## SERVICE BULLETIN

**APPLICABILITY:** 2019MY Forester

**NUMBER:** 12-287-20

**SUBJECT:** Manual Rear Gate, Gate Stays- Design Changes

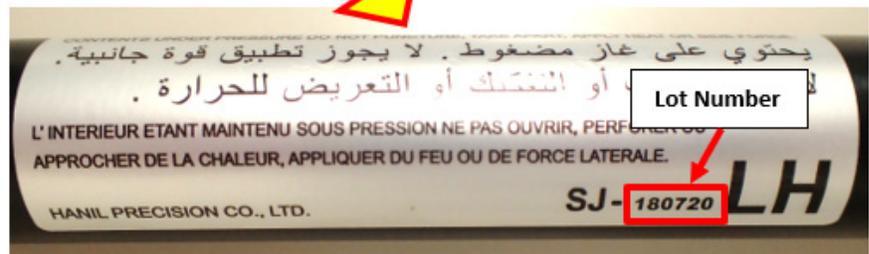
- If the Lot Number is **BEFORE** (lower than) **19024**, **BOTH** stays must be replaced **AS A SET** with new parts. Note the Lot Numbers on the Repair Order for future reference.
